Technical Service Bulletin: tsb100686

New Straight Split Connecting Rods

This Technical Service Bulletin announces a new connecting rod for use on QSK45 and QSK60 diesel engines.

New Straight Split Connecting Rods

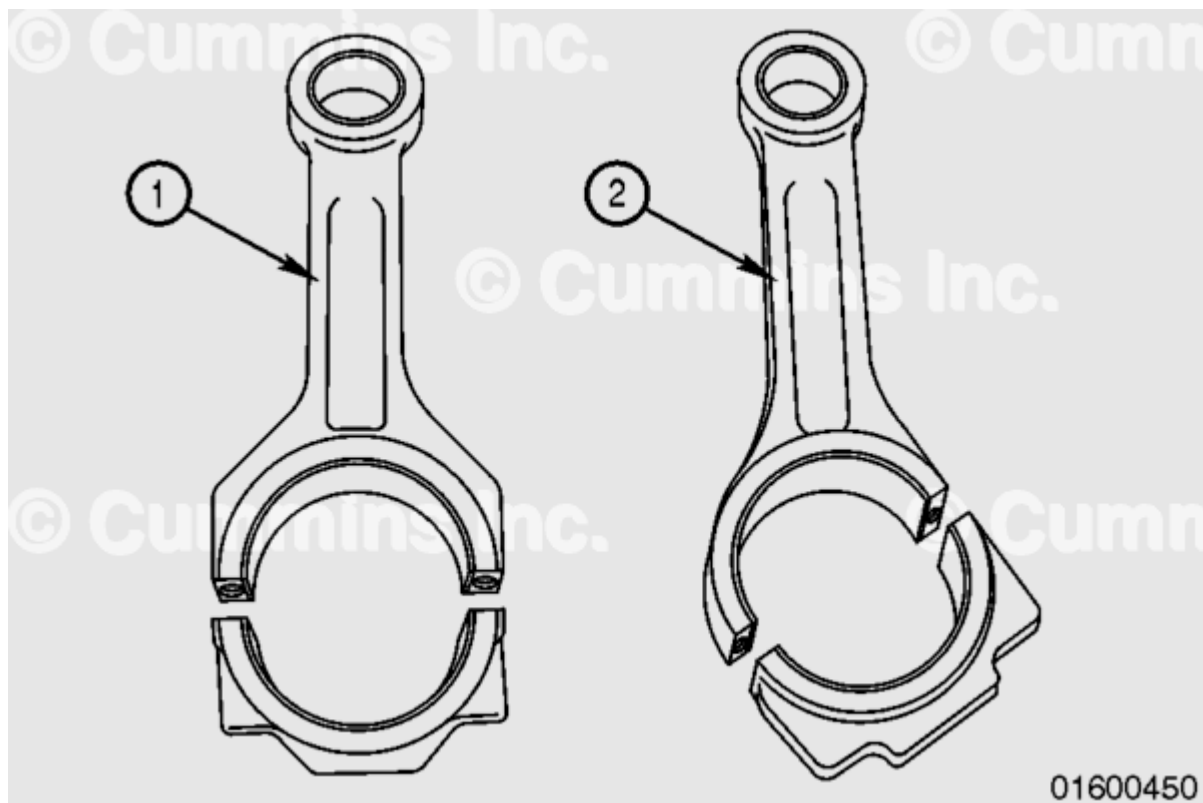
The new connecting rod has changed from an angle split (2) to a straight split (1) bolted joint connection. See the illustration above. The change was introduced to increase the durability of the connecting rod. Straight split (1) and angle split (2) connecting rods can **not** be mixed within an engine. All connecting rods **must** be the same.

Straight split connecting rods can **only** be used with new-style piston cooling nozzles and cylinder blocks which contain the new casting changes, or have been modified. Cylinder blocks built prior to 22 January 2008 and ESN first 33172060 require machining to allow for the new hardware. Contact an Cummins® Authorized Repair Distributor for further assistance with cylinder block machining requirements.
